WORKSHOP AGENDA

Planning Commission

Item Title: Preliminary Plat - Blair Ridge - One (1) Lot on 15.80 Acres. Requested by SEC, Inc. Property located on Blair Road (Tax Map 29, Parcel 21.01). R-3 (High Density Residential) Zoning District. Property owned by 303B Partners.

Item Title: Site Plan - Blair Ridge - 141 Dwelling Units in 26 Buildings. Requested by SEC, Inc. Property located on Blair Road (Tax Map 29, Parcel 21.01). R-3 (High Density Residential) Zoning District. Property owned by 303B Partners.

DRAWN: SJA/CFB3
DATE: 12-29-2023
CHECKED:
MAT
FILE NAME:
19258phase1
SCALE:
1"=30'
JOB NO.
19258
SHEET:
C2.2

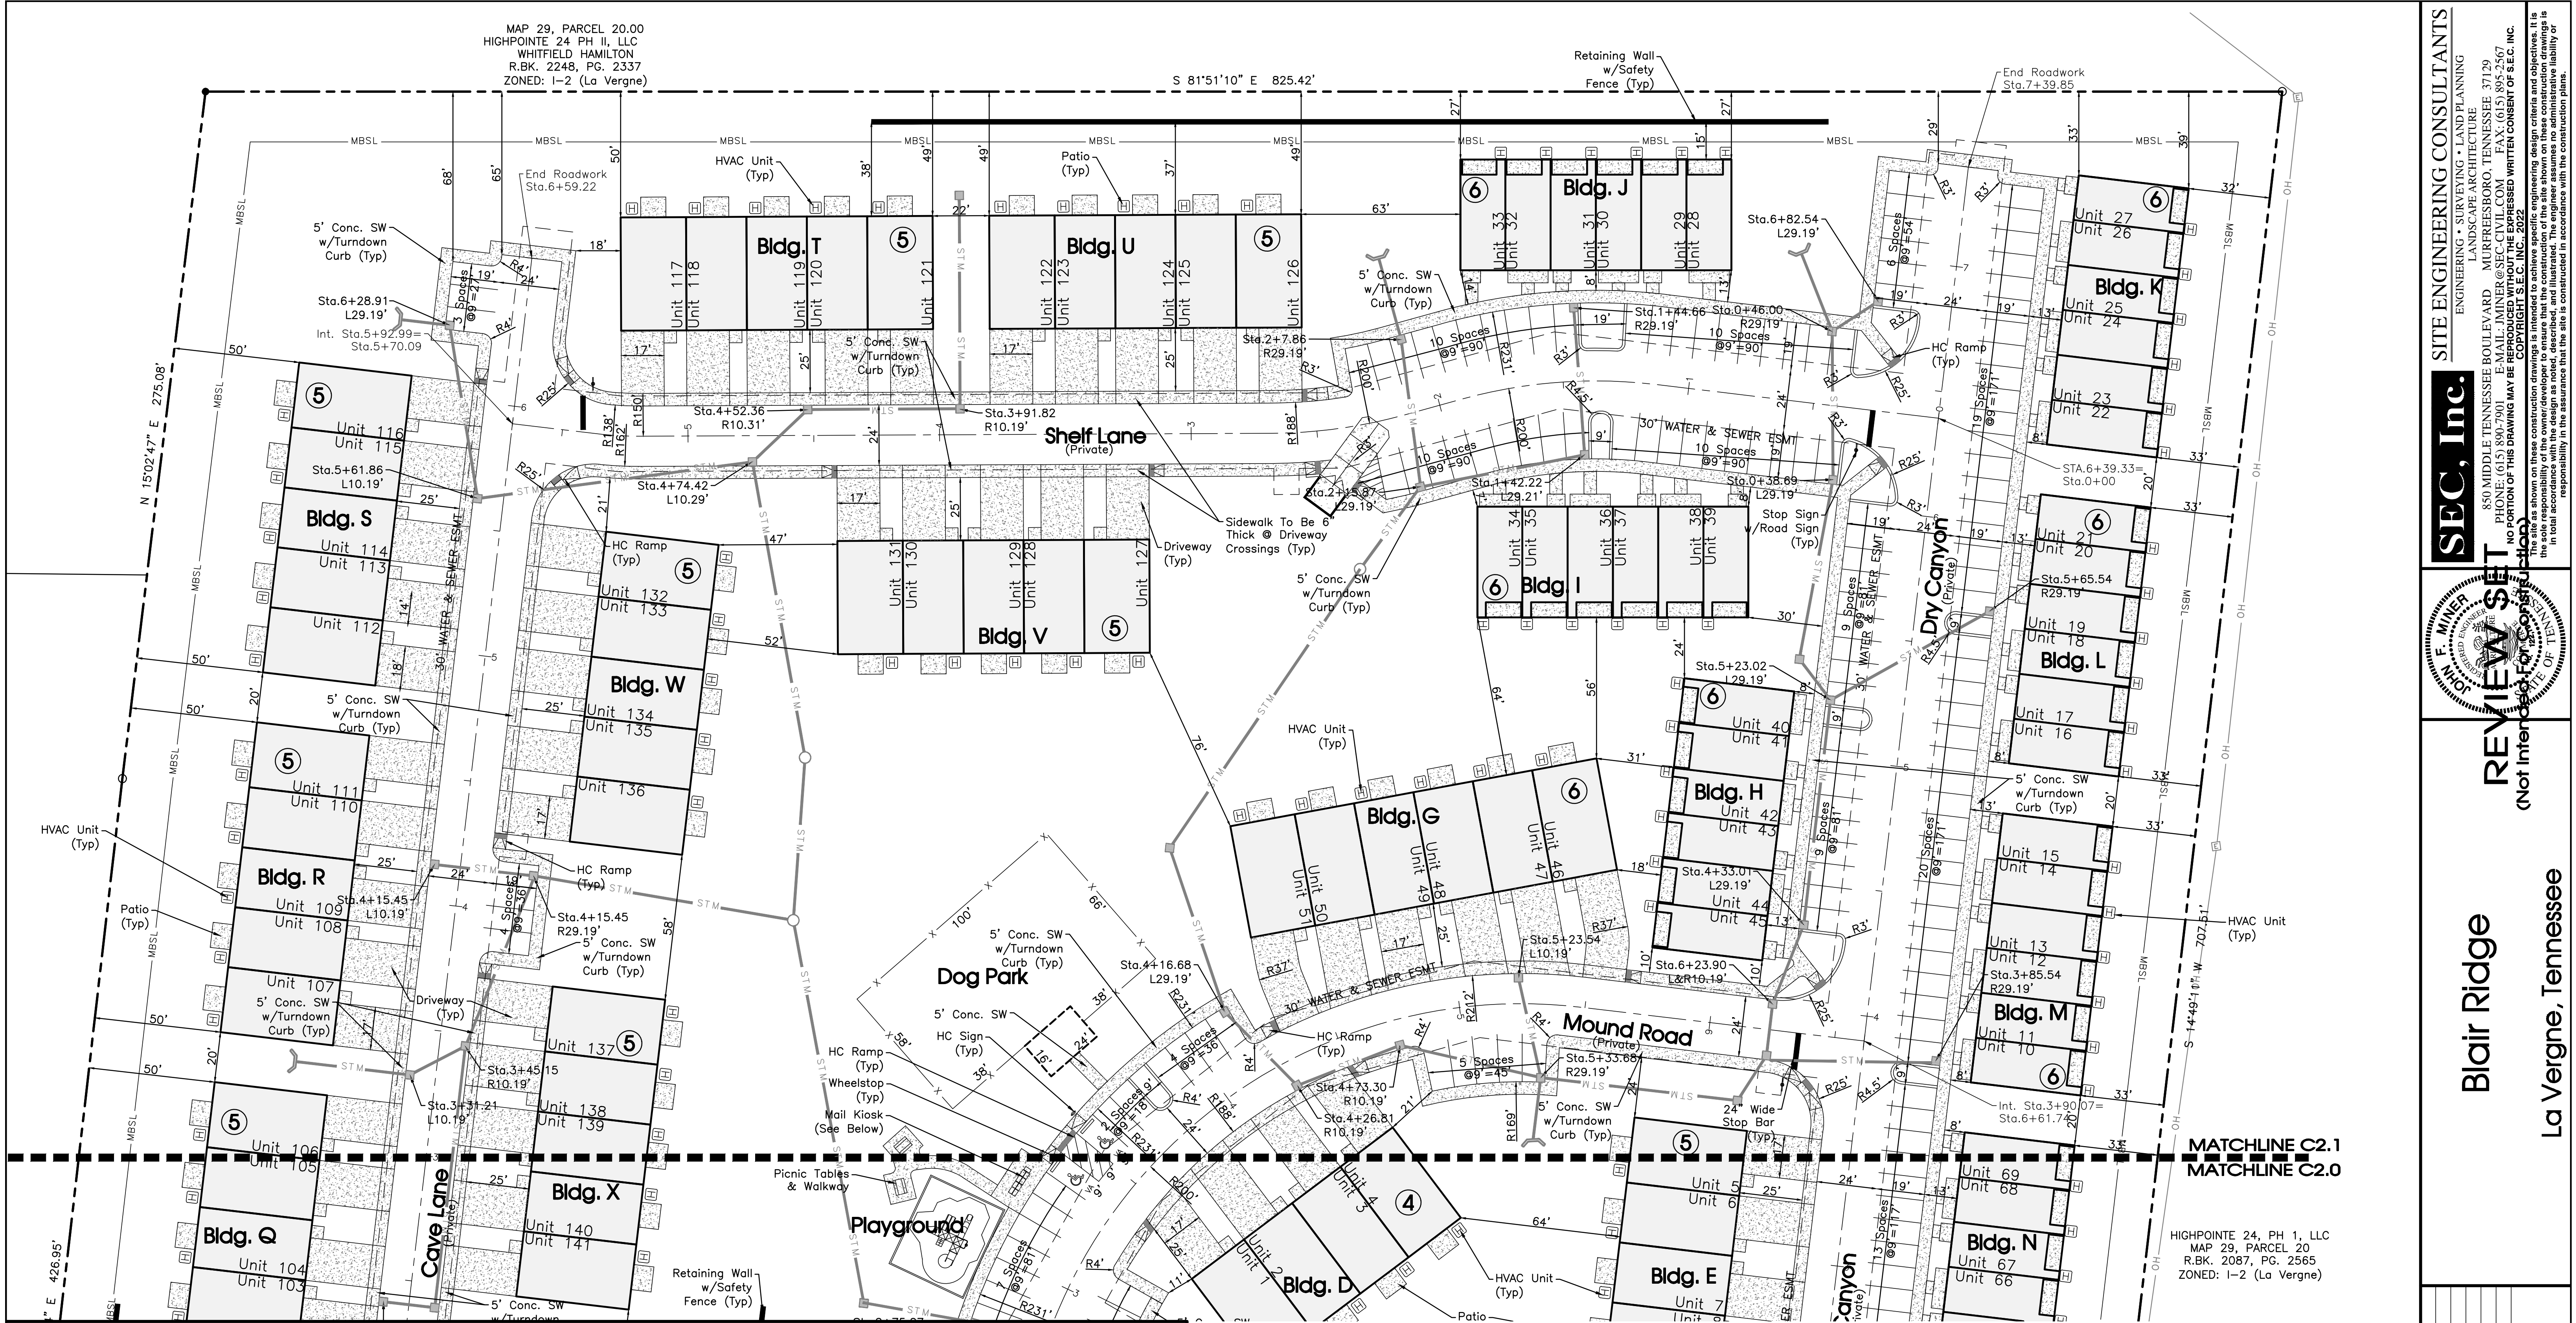
1. Sht C2.2: Existing waterlines in Blair Rd are incorrect, missing, and show improper connectivity. The City potholed these utilities and Scott Tatalovich sent the data to the Engineer (John Minor) on September 20, 2022 at 5:27 p.m., please incorporate the 6-inch and 12-inch waterlines per that pothole data.

DRAWN: SJA/CFB3
DATE: 12-29-2023
CHECKED: MAT
FILE NAME: 19258phase1
SCALE: 1"=30'
JOB NO. 19258
SHEET: C2.3

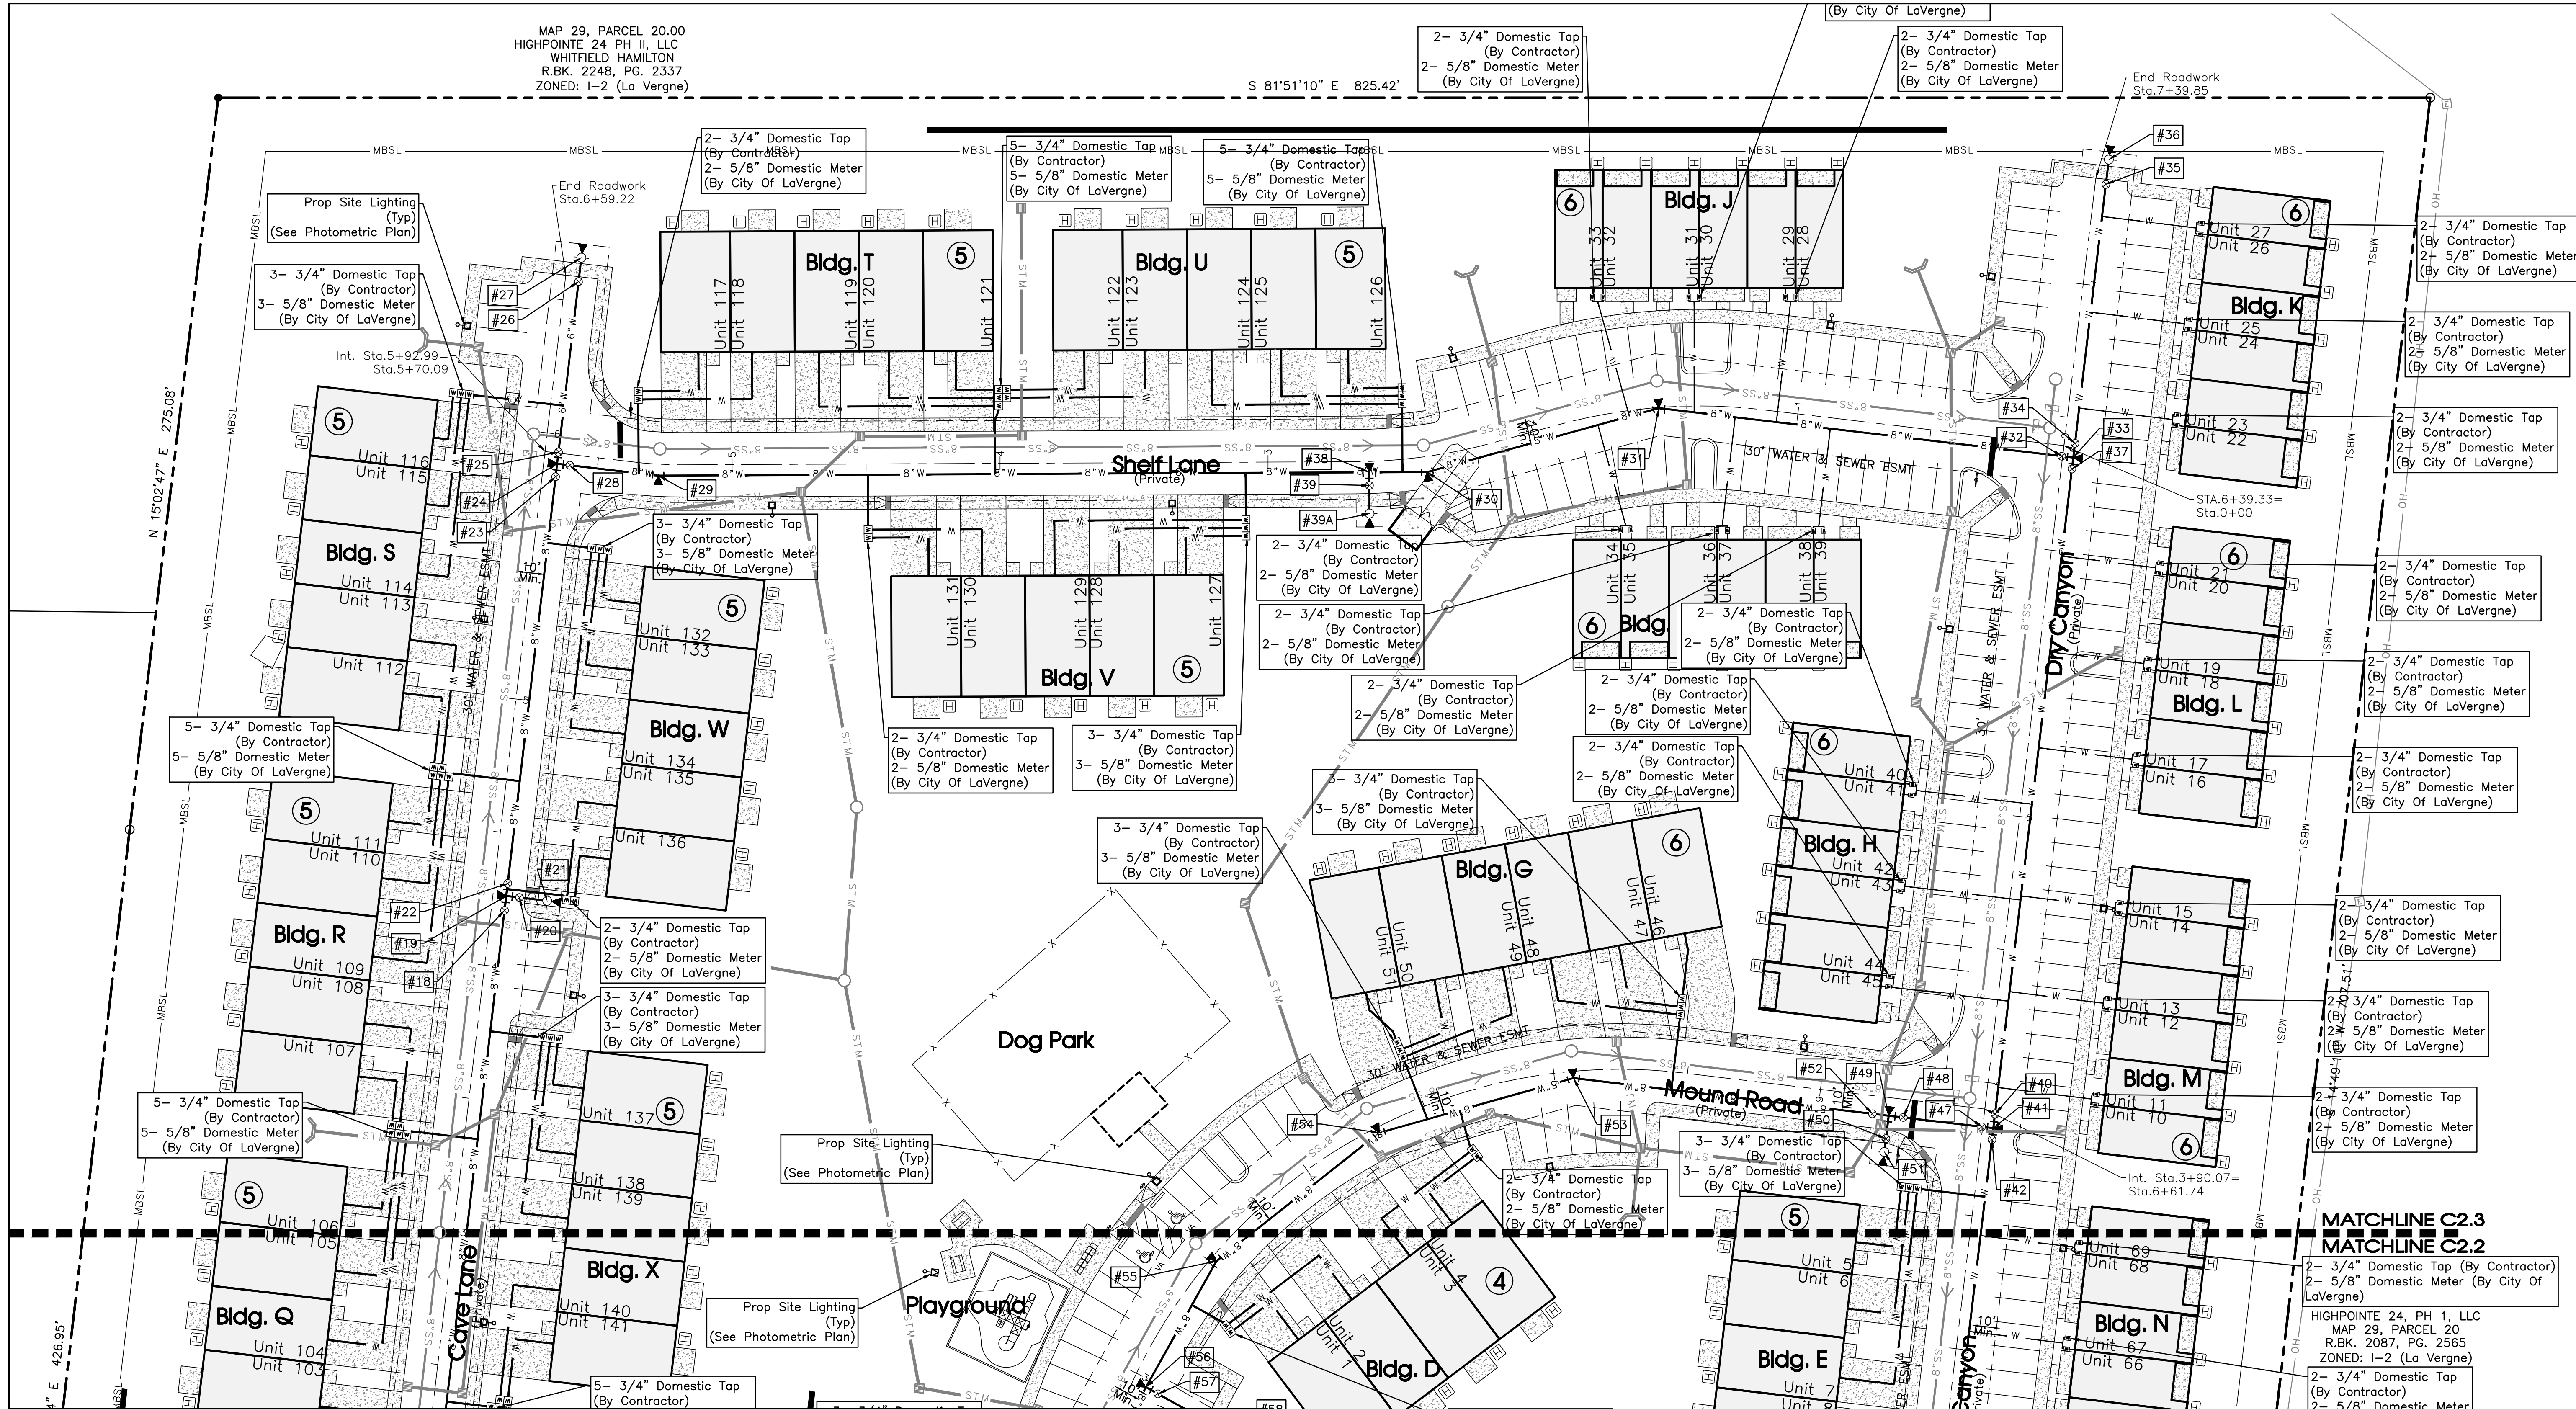
5. Sht C2.3: Add FH, near sec of building U on Shelf Ln., current spacing is greater than 500 feet.
6. Sht C2.3: Move FH (item#39) on Dry Canyon to end of line (north of current location), and remove blow off assembly at end of line.

C-0.0

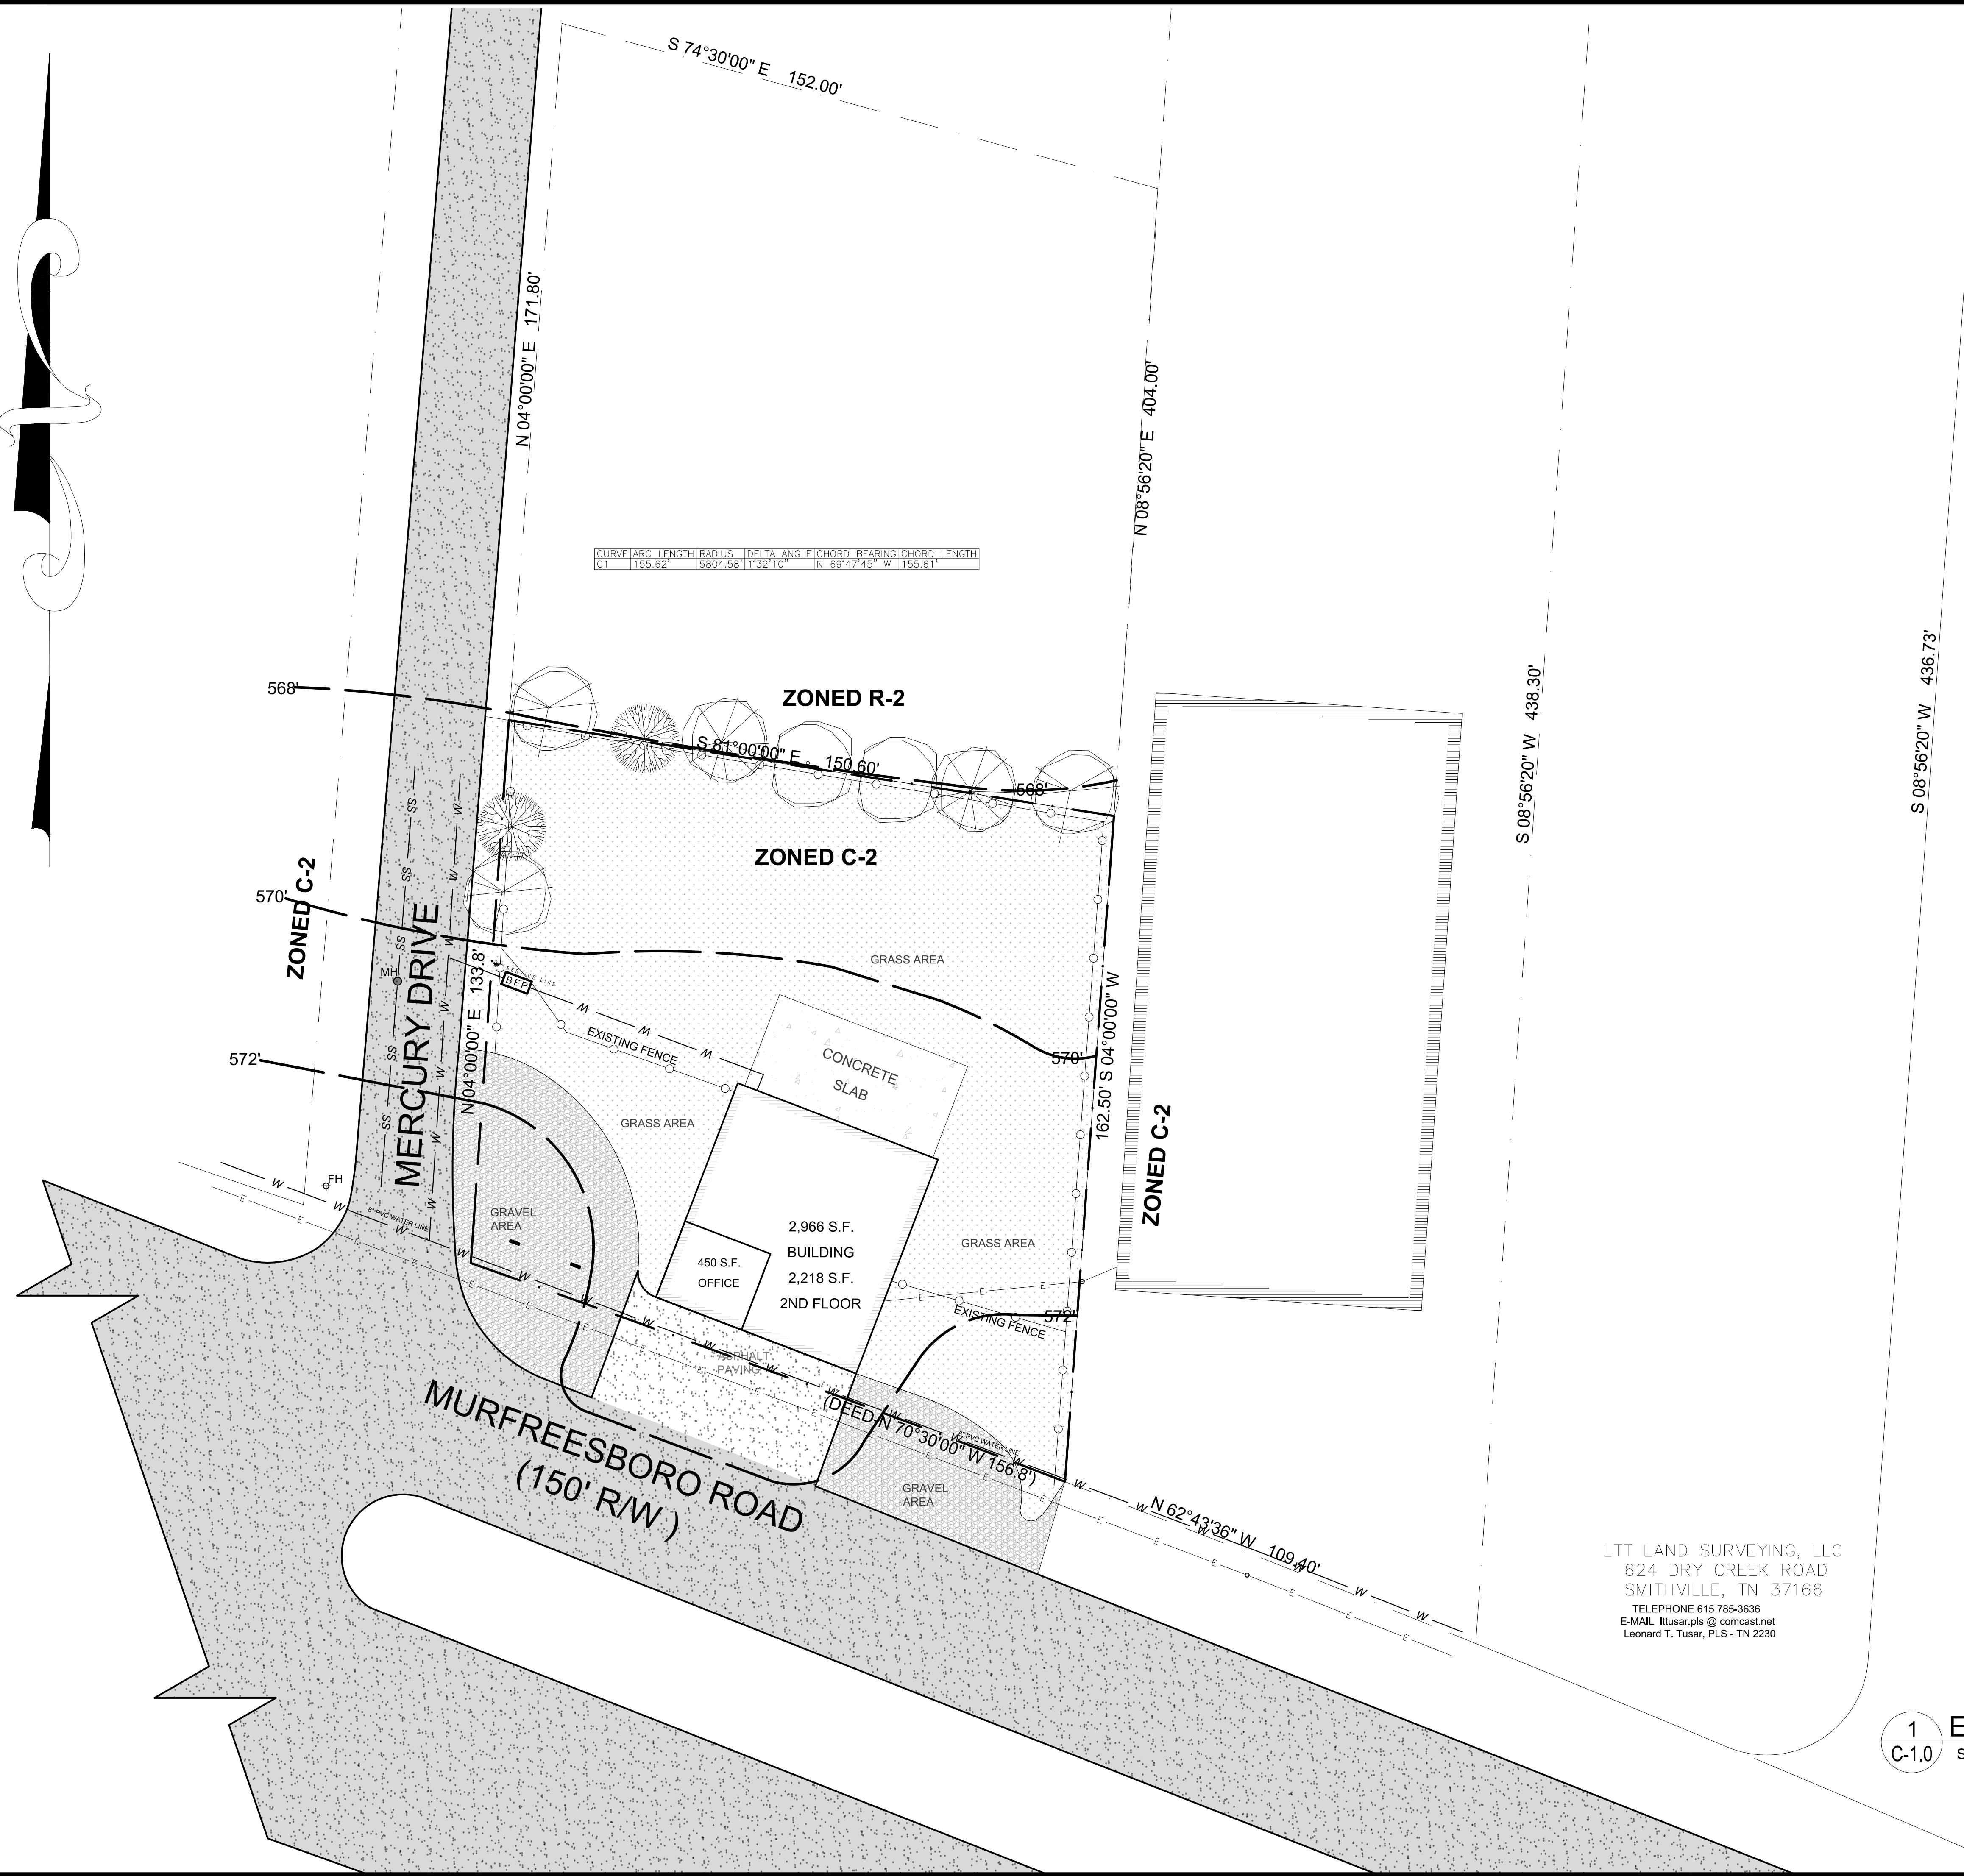
8. (C-0.0) Add note regarding the flood zone based on the May 2023 FIRM mapping from FEMA.
9. (C-2.0) Stormwater Department would prefer that the garbage cans not be located immediately adjacent to the curb cut into the detention basin as this maximizes the potential for illicit discharge.
